1994 Corvette: Service Bulletin: Garage Shift Delay Engagement (New Garage Shift Package)

Bulletin Number: 47-71-20A

REVISION: 09/12/94

ORIGINAL GARAGE SHIFT PACKAGE

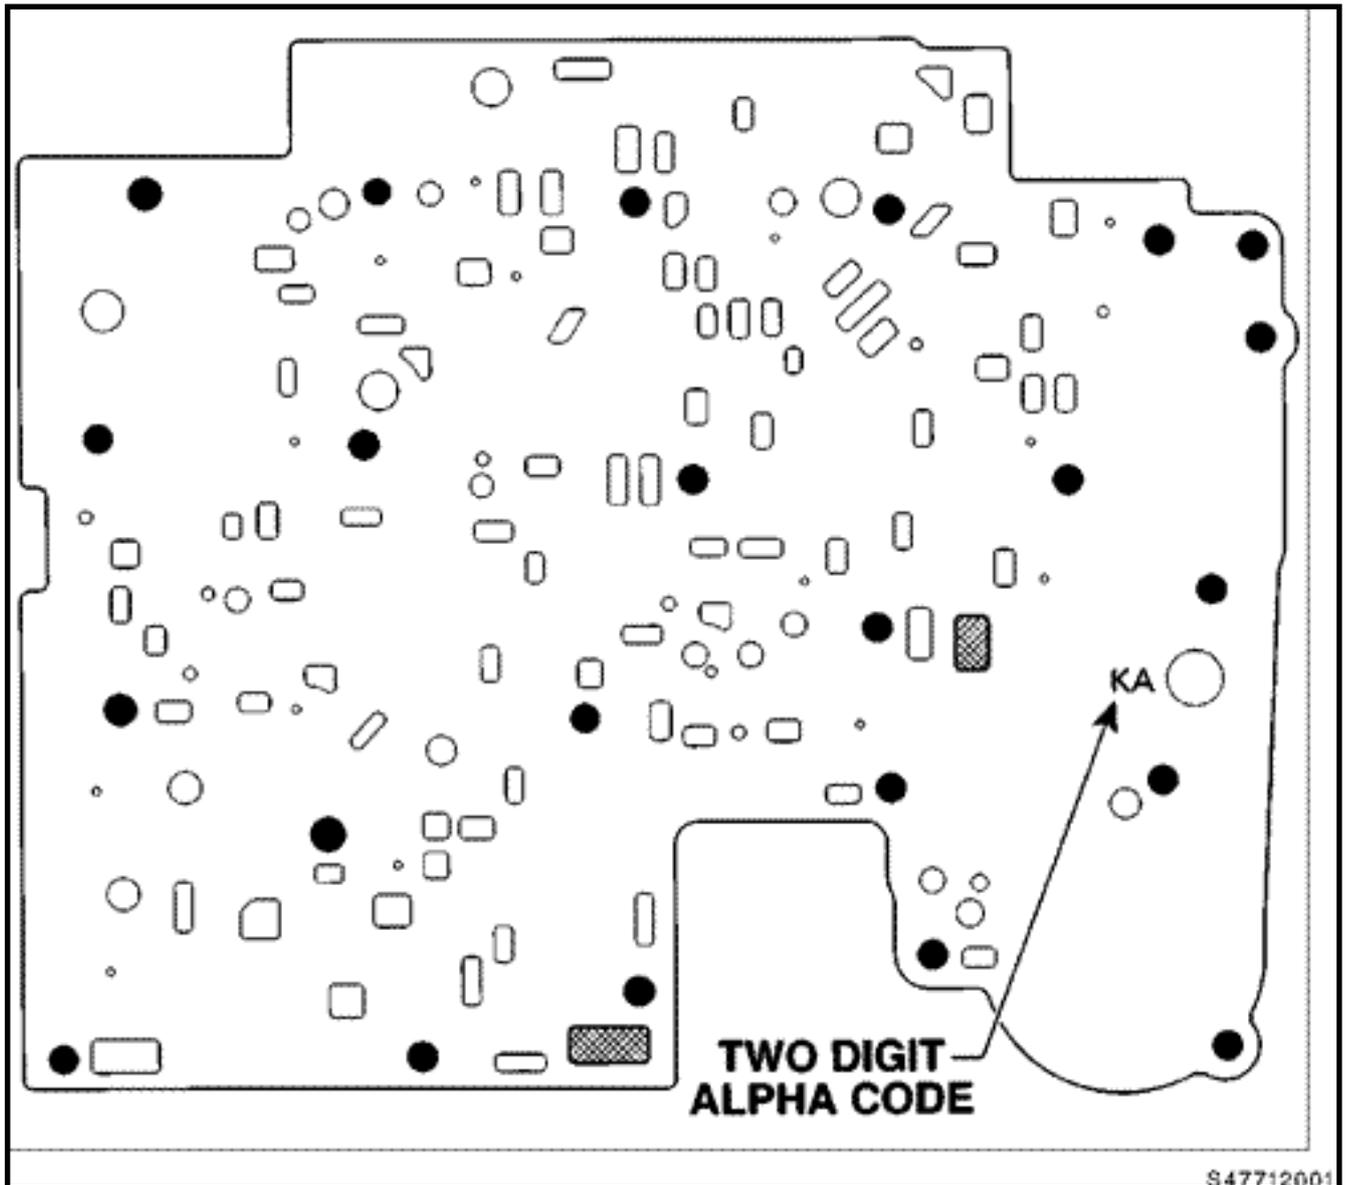
WHEN PERFORMING ANY OTHER REPAIRS ON A 1994 VEHICLE EQUIPPED WITH A HYDRA-MATIC 4L60-E TRANSMISSION BUILT BEFORE MARCH 7, 1994 (JULIAN DATE 066), THE SPACER PLATE IDENTIFICATION MUST BE

CHECKED TO SEE IF THE TRANSMISSION HAS HAD A NEW GARAGE SHIFT PACKAGE INSTALLED TO BE SURE THE TRANSMISSION IS BEING SERVICED WITH THE PROPER PARTS. SEE THE FOLLOWING CHART FOR SPACER PLATE IDENTIFICATION.

THE NEW SPACER PLATES MUST BE USED WITH THE ENHANCED GARAGE SHIFT PACKAGE AND THE ORIGINAL SPACER PLATES MUST BE USED WITH THE ORIGINAL GARAGE SHIFT PACKAGE. THE SPACER PLATES AND GARAGE SHIFT PACKAGES ARE CALIBRATION SENSITIVE; MIXING SPACER PLATES AND GARAGE SHIFT PACKAGES MAY CAUSE PREMATURE FAILURE. WHEN A GARAGE SHIFT PACKAGE IS CHANGED, THE SPACER PLATE MUST ALSO BE CHANGED.

ENHANCED GARAGE SHIFT PACKAGE

24202371 KA 4SHD, 4TLD, 4MJD, 4CAD, 4CBD, 4KAD, 4MND, 4TWD
24202372 KB 4MSD, 4TAD, 4TBD, 4MDD
24201478 LM 4CCD, 4CFD, 4KBD
24201479 LN 4CHD, 4CJD, 4KCD, 4CPD
24201480 LO 4CMD, 4CUD, 4KPD
24201477 LL 4SAD
24201475 LJ 4HBD
24201476 LK 4HDD, 4HCD
24202366 KK 4BBD
24202368 KL 4BWD
24201473 LG 4FDD, 4SFD
24201474 LH 4FFD, 4YDD
24202370 LP 4BFD
24202367 LT 4BCD
24202369 LS 4AHD
